**HEARING REPORT PURSUANT TO SECTION 42A
OF THE
RESOURCE MANAGEMENT ACT 1991**

COUNCIL REF: RM190270

Figure 1: Planning Map and Location of the CMA Boundary

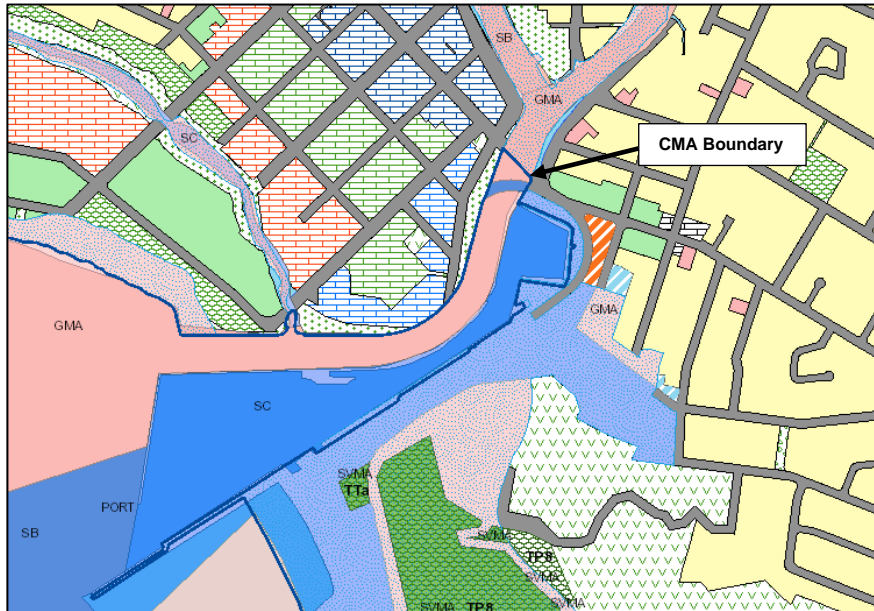
- 5.9 While there is no direct discharge to the CMA, it is noted that a primary wet weather overflow discharge point (Wainui Road) is located just upstream of the road bridge. The boundary of the CMA has been defined in the Tairāwhiti Plan as the oceanside edge of the road bridge and is shown in **Figure 1**. Therefore the overflow point is very near the boundary of the CMA¹¹.

Figure 2: Gisborne Wastewater Network Pipe Gradients (source Figure A1 Beca, 2017)

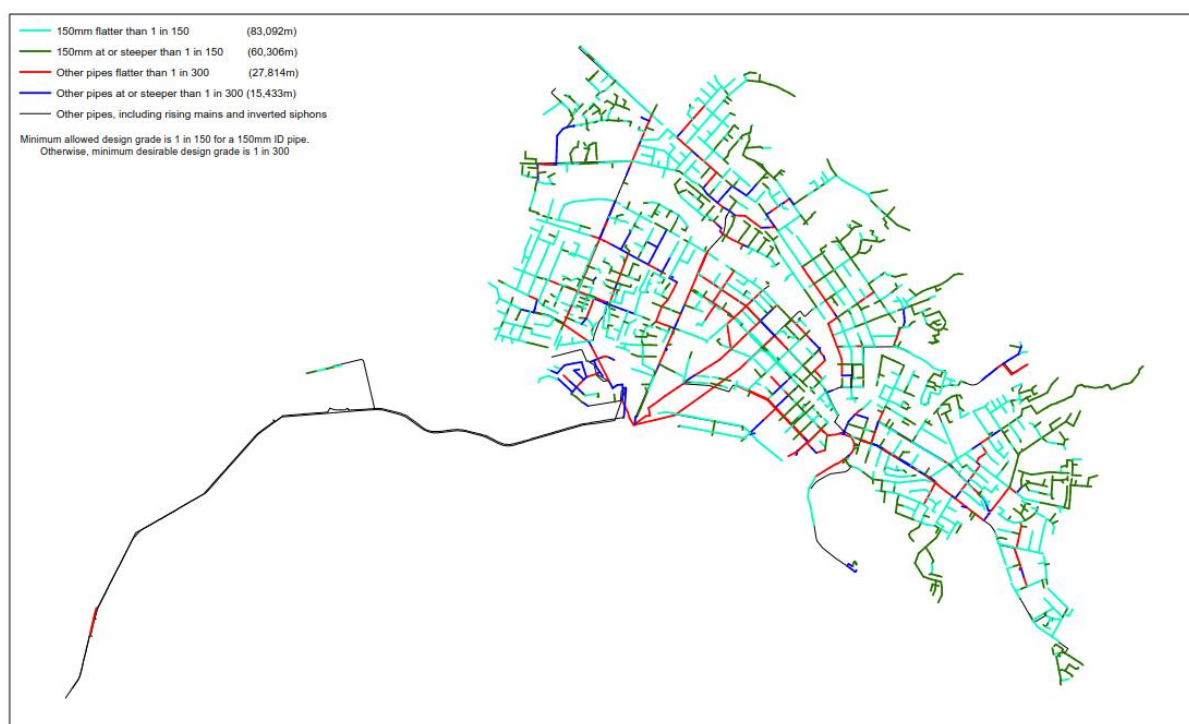
- a. Build-up up fats and grease
 - b. Sanitary and wet wipes and foreign objects (toys, clothing etc) and
 - c. Sections of the wastewater network that do meet minimum desirable grades (Figure 2

Figure 4: I&I network impacts (sourced: application)

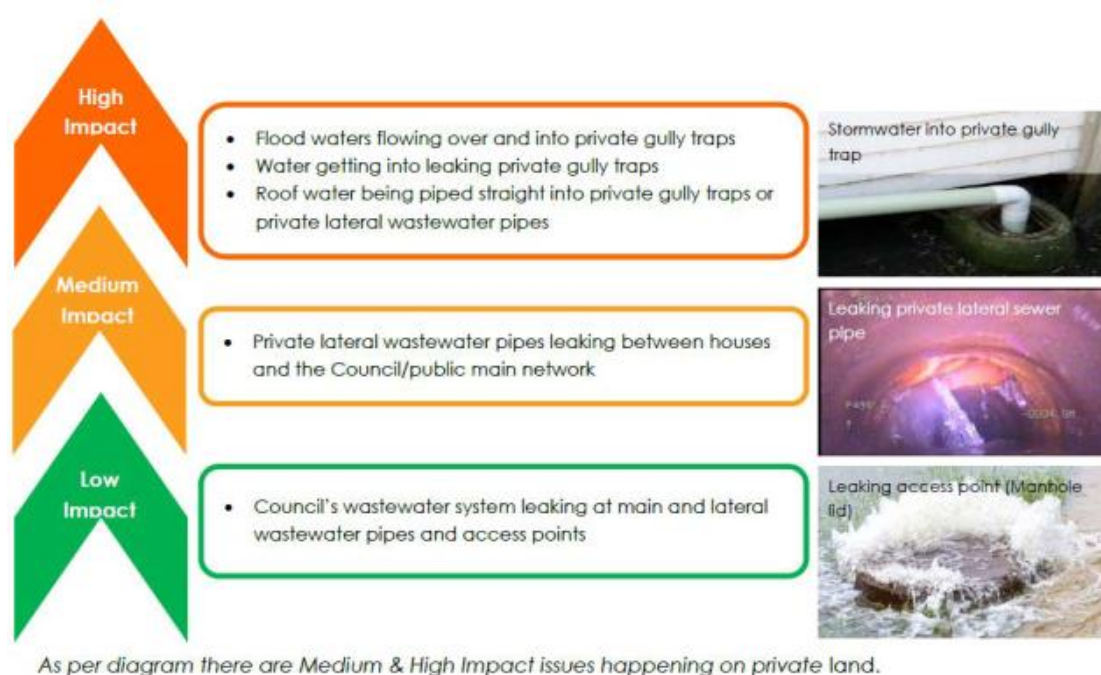
42. I generally agree with the Applicant's approach and conclusions, noting that I have concerns I raise below:
- a. The Applicant has recorded instances where the overflow valves have not been opened for events that exceed the 50% AEP and in other instances where overflow valves were opened for events less than the 50% AEP, suggesting that there are other competing influences controlling the frequency and volume of wet weather overflows.
 - b. Rainfall derived I&I (RDII) is a complex, it is often as a result of localised sections of the network that disproportionally contribute (i.e., several illegal connected gully traps) to I&I problems. The volume of I&I is not static and can be impacted by a range of factors such as ground water levels that fluctuate seasonally, rainfall intensity, tidal levels, pipe condition

Figure 6: Sources of Inflow & Infiltration (source AECOM Australia)

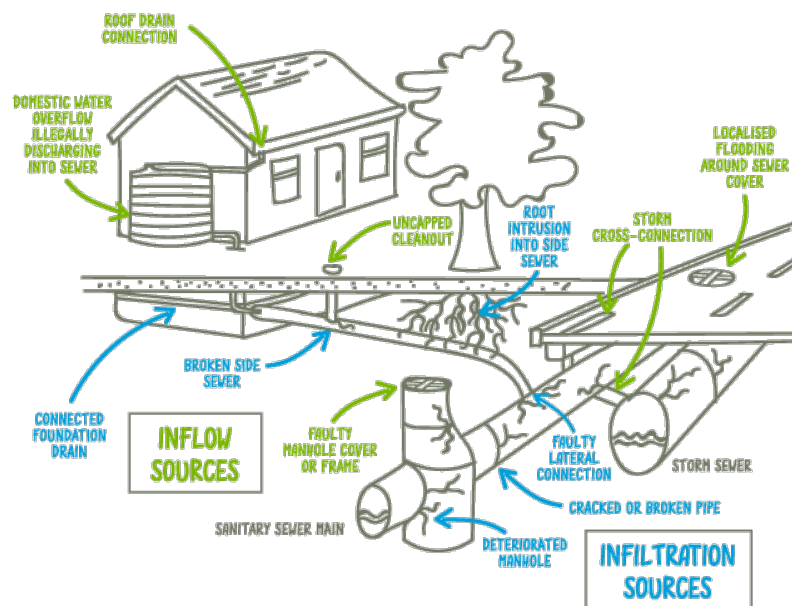
51. My principal concerns are:
- a. The reduction in inflows from the private wastewater network required to achieve compliance with the proposed containment standards is high.

- b. As 'private' sources of stormwater are removed additional sources of inflow may appear, providing capacity for other sources of I&I.
52. Despite the concerns above the Applicant has committed to overflow volume and frequency reductions, which, if required, can be achieved by upgrades to the network. I would encourage the Applicant to consider ongoing flow monitoring to track the success of the DrainWise Programme.
